AGENDA
PLANNING AND ZONING COMMISSION WORK SESSION
City Hall, 385 South Goliad, Rockwall, Texas
Council Chambers
November 26, 2019
6:00 P.M.

PLANNING AND ZONING COMMISSION CASE MEMO

TO: Planning and Zoning Commission
DATE: November 26, 2019
APPLICANT: Arlyn Samuelson; *Westwood Professional Services*
CASE NUMBER: P2019-044; *Lot 3, Block A, SPR Packaging Addition*

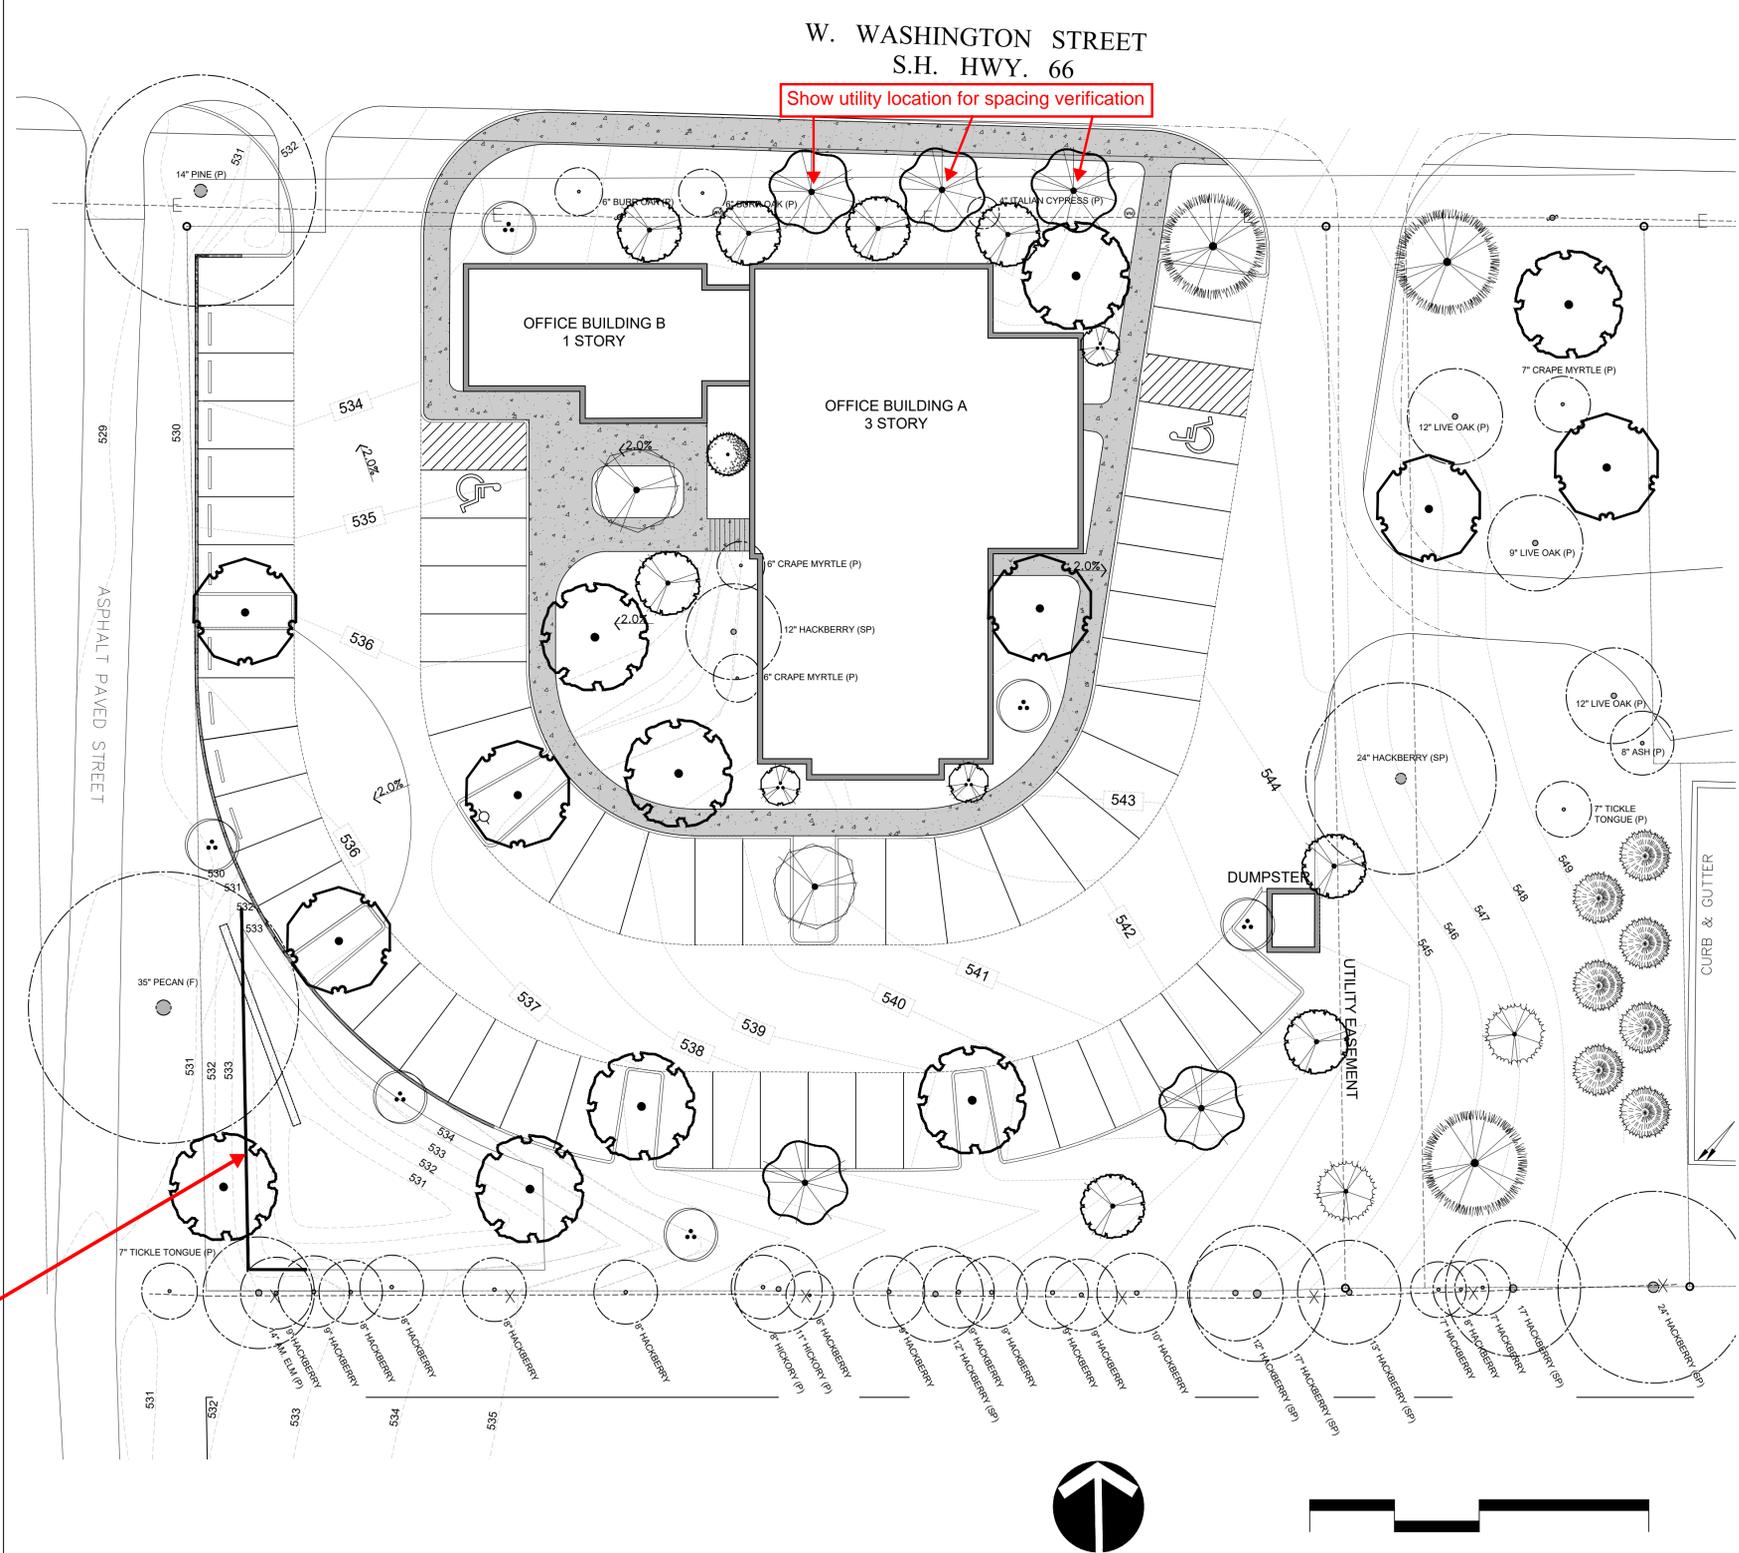
No walls in detention

Show utility location for spacing verification

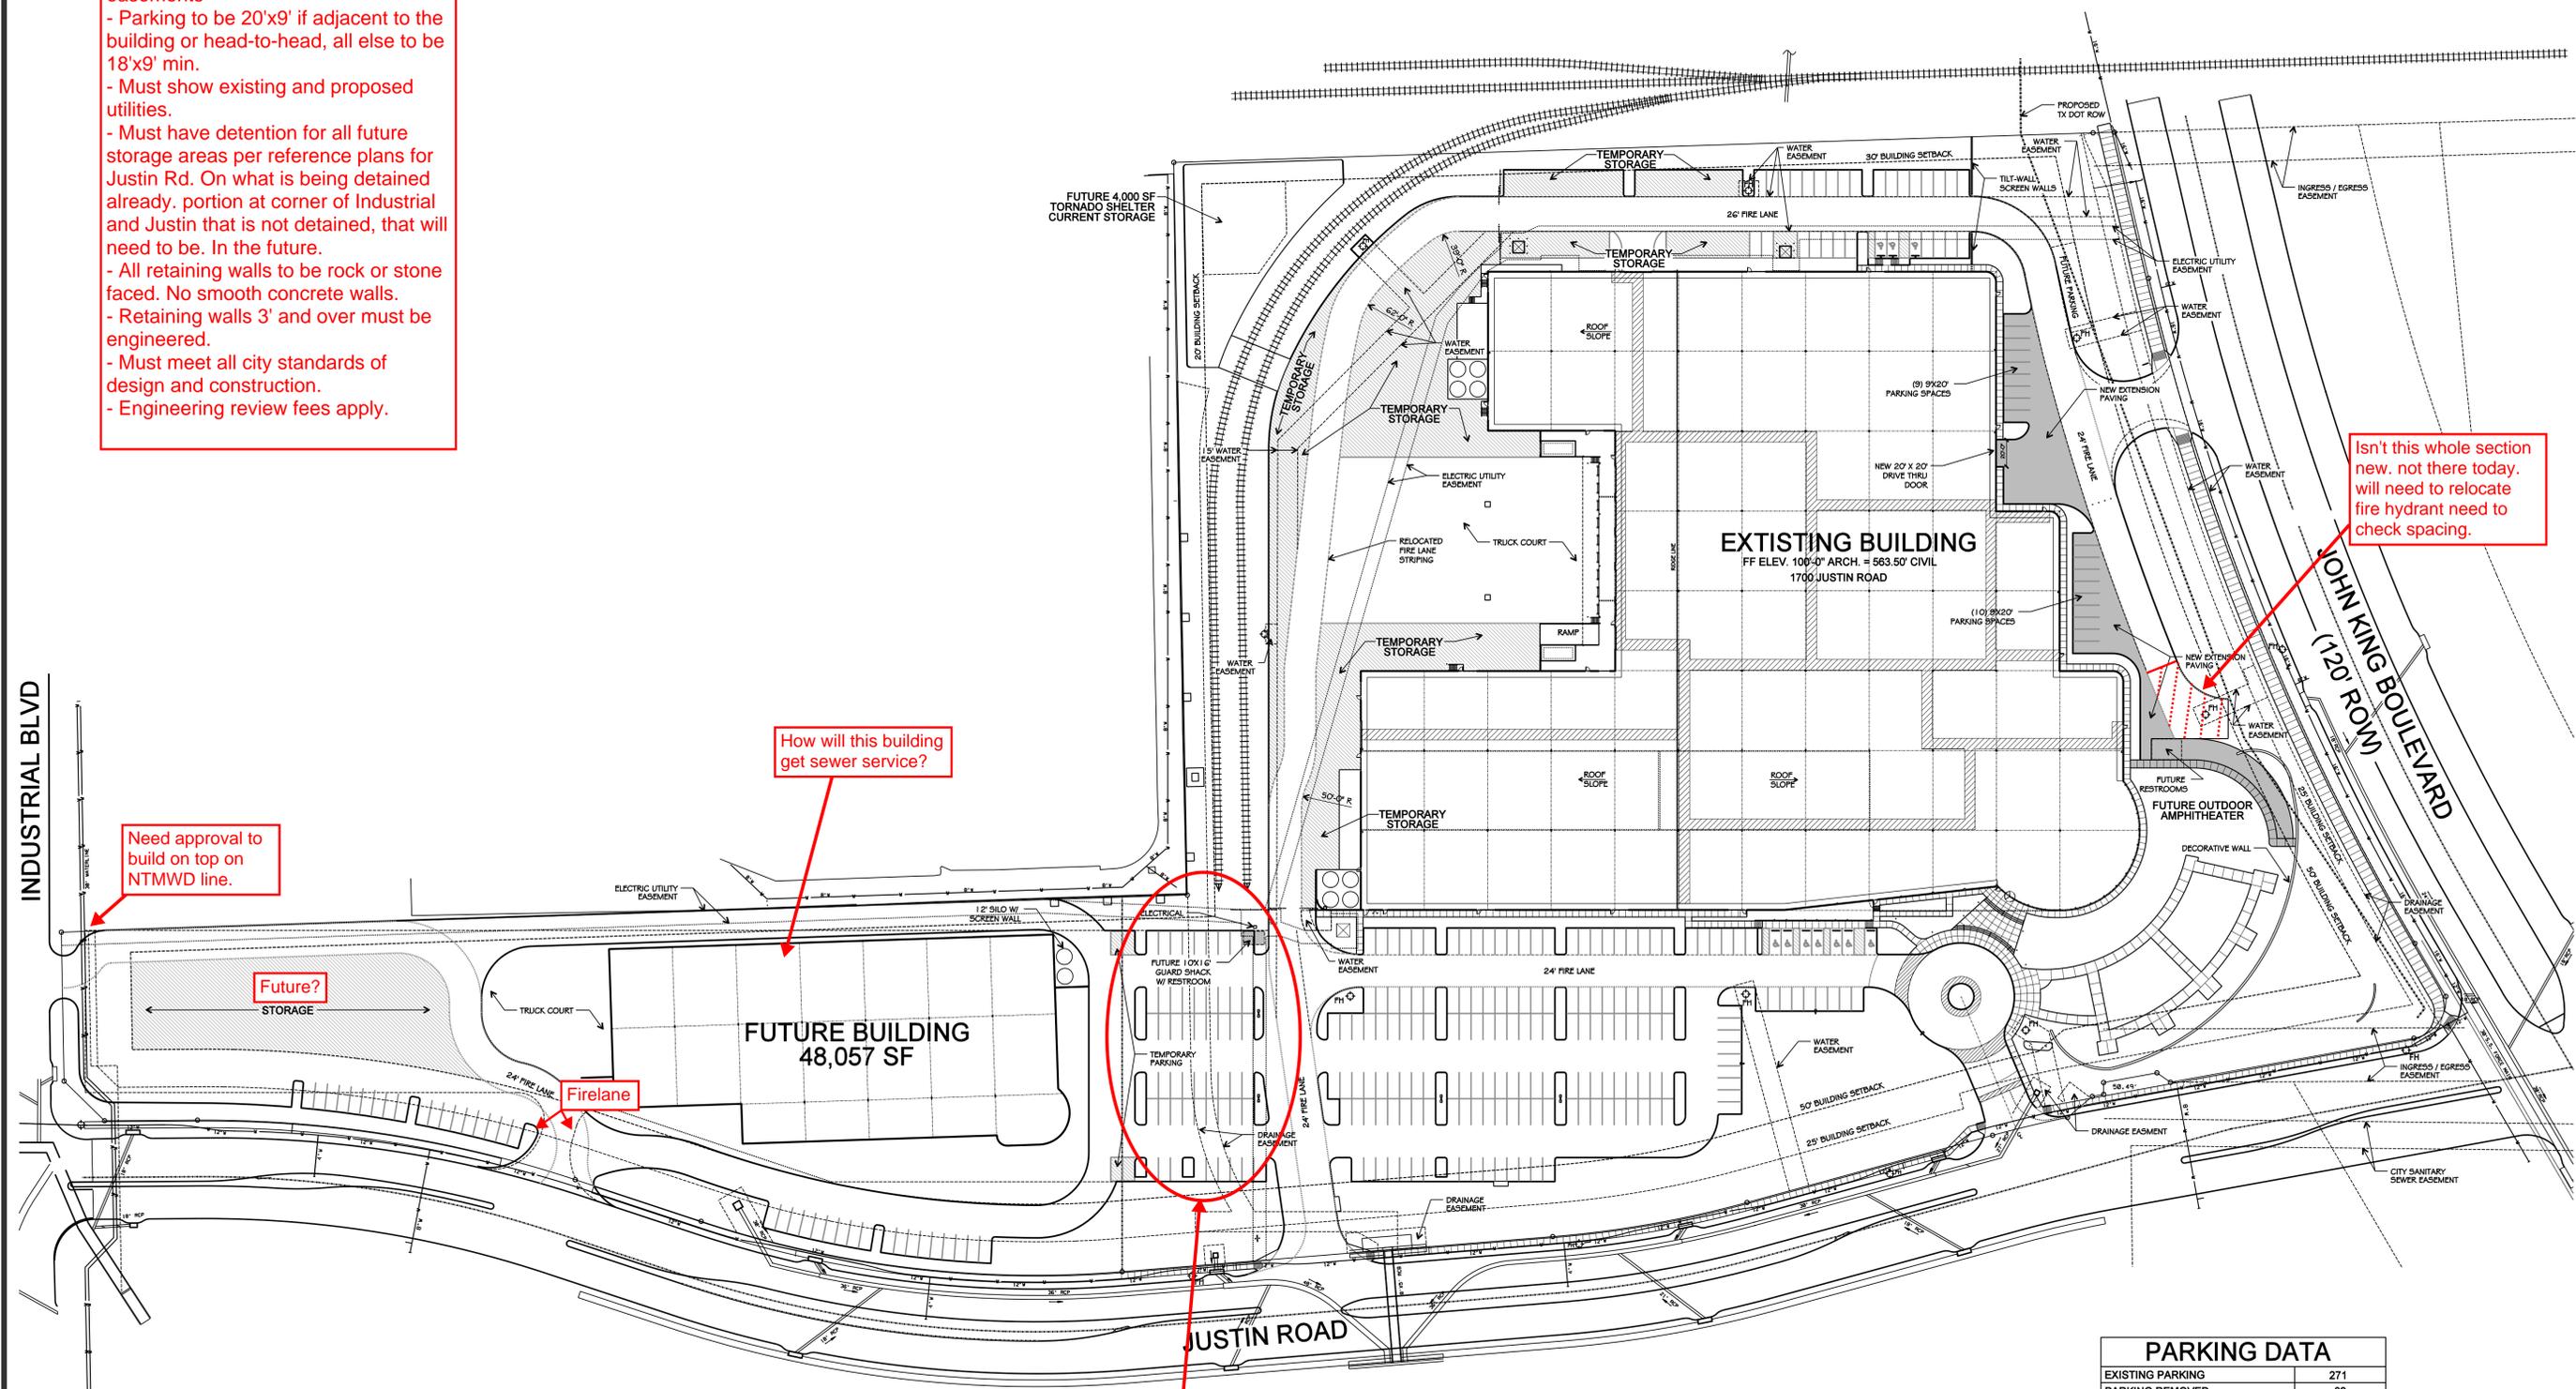
How will this building get sewer service?
